COUNCIL ASSESSMENT REPORT

Panel Reference	2018SWC069
DA Number	DA 1894/2018/JP
LGA	The Hills Shire Council
Proposed Development	Demolition of existing structures, subdivision of land into three lots, construction of local and temporary roads, construction of a residential flat building comprising 50 units and two multi dwelling housing developments totalling 40 townhouses, with basement parking.
Street Address	Lot 70 DP 11104 25 Mason Road, Box Hill
Applicant/Owner	J S Architects Pty Ltd Mr and Mrs Chang
Consultant/s Architect: Town Planner: Acoustics: Arborist: Environmental Investigation: Engineering: Traffic: Surveyor: Archaeology: Quantity Surveyor: Accessibility:	J S Architects Pty Ltd DDC Planning Rodney Stevens Acoustics MacKay Tree Management Geotesta Pty Ltd Indesco EB Traffic Solutions Pty Ltd C and A Surveyors NSW PL Baker Archaeology RIC-QS Pty Ltd JS Architects
Date of DA lodgement	24 April 2018
Number of Submissions	Nil

report for the Panel's consideration	
Report prepared by	Kate Clinton, Senior Town Planner
Report date	15 October 2020

Plan of Subdivision (May 2019) with temporary access road between Nos. 23-23A and 25 Mason Road to Tucana Street. Access to Mason Road deleted.

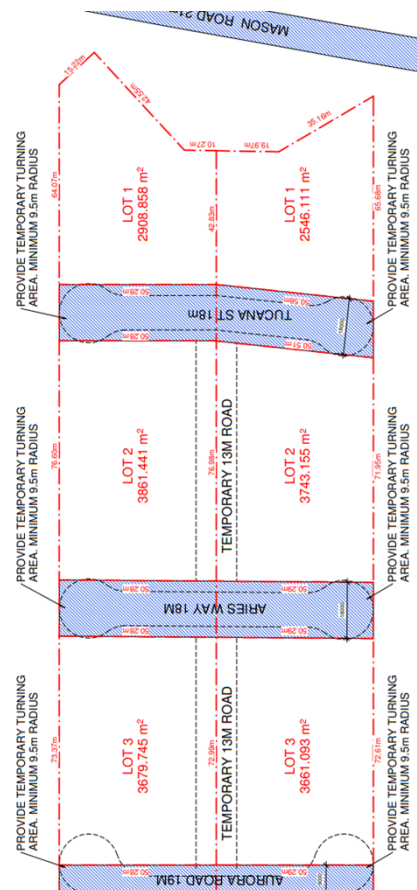
The subject site is currently accessed from Mason Road via a loop road within an adjacent road reserve which is also zoned R4 High Density Residential. Proposed Lots 1, 2 and 3 rely on vehicular access via roads that are not yet constructed on adjoining land. The future road layout is illustrated on the Indicative Layout Plan in Attachment 7.

Future access to proposed Lot 1 from Mason Road is denied by the Box Hill DCP since it is a sub-arterial road. Therefore proposed development Lot 1 must only be accessed via future Tucana Street. Proposed development Lots 2 and 3 are currently isolated, since future roads proposed to provide access (Aurora Street and Aries Way) are not yet constructed through the adjoining land.

Since Aurora Street is located half within the subject site and half within the adjoining land at No. 27 Hynds Road, the consent of land owner is required to enable the partial width (9.5m) construction of that road which would provide 2-way vehicular access.

In addition to landowner's consent, concept engineering plans must show these works as being proposed as part of the subject development application. It is not appropriate to approve a development unless the plans show an engineering concept for the civil works upon which the development relies. This matter is addressed in Section 13(b) of this report in relation to outstanding engineering matters.

East/West Section (3) – April 2018

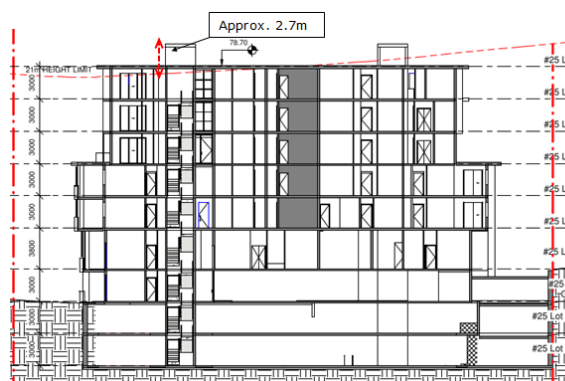
Originally, the application proposed a maximum height of RL80.70 to a lift shaft according to the notations on Elevation Plans submitted in April 2018. A Section is not provided through either lift shaft so the following Section plan is shown measured below for illustration. The Northern Elevation is highlighted below since it provides the RL, and is measured to provide a visual illustration of height above natural ground level only for comparison to amended plans.

Building Height Plane – April 2018

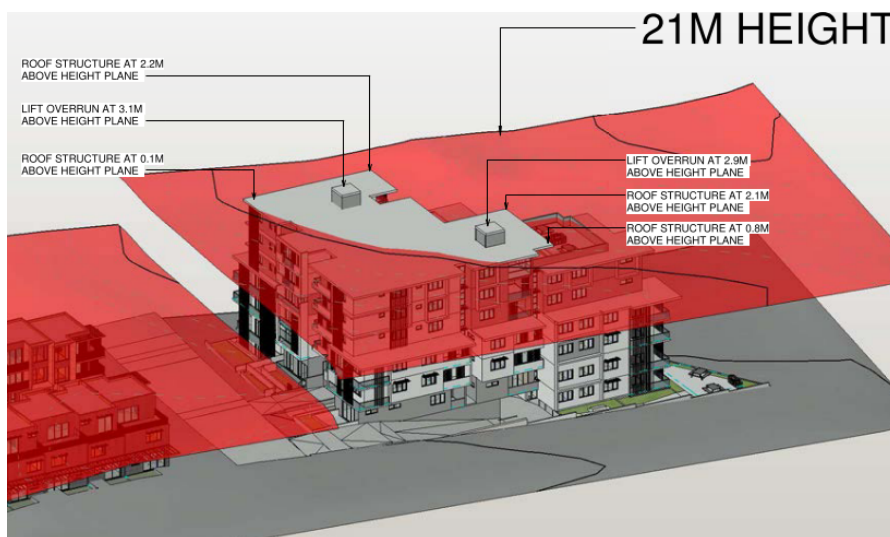
The Building Height Plane indicated that the shafts were 2.9 metres and 3.1 metres above the permitted height of 21 metres, being a maximum height of 24.1 metres. The roof structure was shown on the Building Height Plane to be a maximum height of between 21.1 to 23.2 metres.

Amended Building Height Plane - June 2020

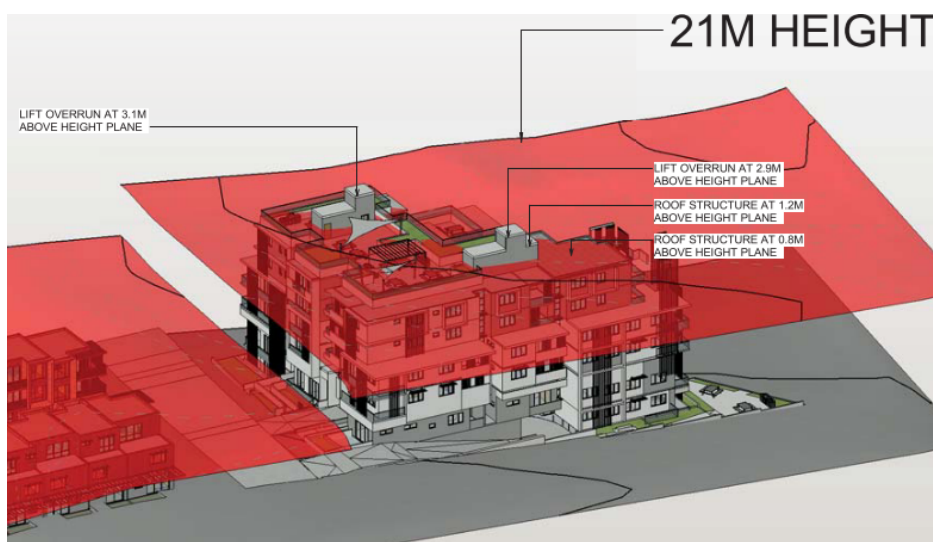
Following the deletion of the 7th storey, the amended Building Height Plane (below) still indicates a maximum height of 23.9 and 24.1 metres (showing encroachments of 2.9 and 3.1m to the lift shafts), but has reduced the height of roof structures to between 21.8 and 22.2 metres (encroachments of 0.8 to 1.2 metres).

However, the amended Elevations show an *increase* in the lift shaft heights from RL80.70 in the original plans to RL 81.95. A revised Section Plan was not submitted in June 2020 therefore the Section from May 2019 is measured below for illustration.

Therefore, since RL's are not provided on the Building Height Plane and since amended Sections and Elevations indicate an increase in building height, the applicant is required to clarify the maximum height of the lift shafts / roof structures and the resulting variation of the 21m height plane.

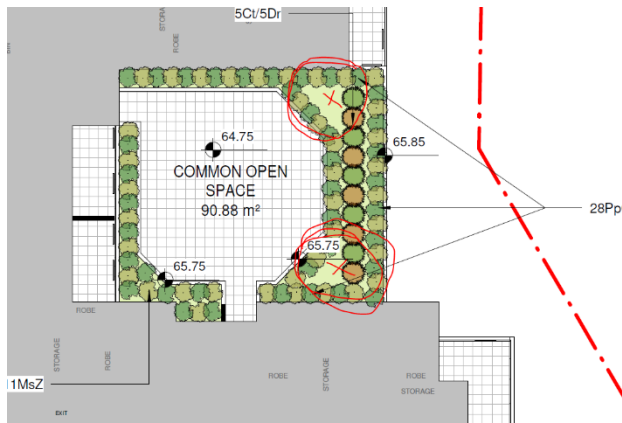
Additional tree cover is required to provide privacy between balconies and common open space, enhance streetscape and increase biodiversity of the area.

- Provide screen planting to boundaries and in front of ground floor units. Currently the ground floor landscaping consists of two species of groundcovers, two species of grasses and 9 trees.
- Screen planting to boundaries to be minimum 2m wide and species that will reach a minimum height of 3m at maturity.
- Additional variety of tree, shrub and groundcover species is to be included in the planting palette for a development of this size. Plant species selected are also to be suitable to microclimatic conditions created by the built form. In particular, the southern boundaries which will be heavily shaded. Fifth floor landscaping lacks variety and planting to be enhanced with feature planting. The 1st floor open space would benefit from the addition of trees eg Pyrus, Magnolia, Elaeocarpus.

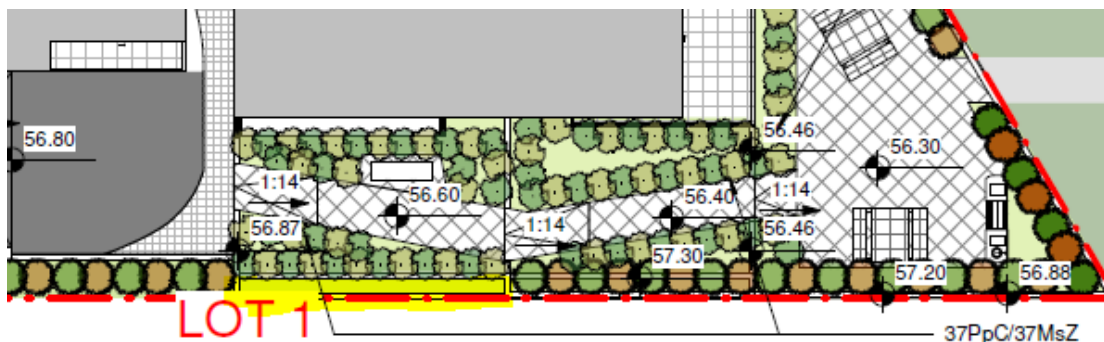
- All trees planted as part of the approved landscape plan are to be minimum 75 litre pot size. All shrubs planted as part of the approved landscape plan are to be minimum 200mm pot size and plant spacings to be between 500mm to 2m depending on species. Groundcovers are to be planted at 5/m². The proposed densities of planting are to be amended.
- Central driveway to be landscaped either side of driveway. Reduce pedestrian entry path width to east of driveway to allow for landscaping. To western side relocate pedestrian access to Unit G03 and allow to landscape adjacent to driveway.
- Provide screen planting to top of proposed wall to eastern boundary.

- Remove small areas of turf indicated on plans as inaccessible and difficult to maintain and inappropriate locations for scale of development.
 - Remove the six listed species in Plant schedule that are not used within design. Only include species used in design in Plant Schedule.

- On site detention tank is to be located under proposed paved area so as not to impact on planting and landscape areas. However if location cannot be changed the tank detail is to be amended to allow for minimum soil depth to allow for proposed planting. Location and shape to be reviewed to allow for screen planting between tank and ground floor balcony of Unit LG04 and maintain screen planting between tank and northern boundary. The proposed tree cannot be planted over tank and is to be relocated. Tank location is to be indicated on Landscape Plan.
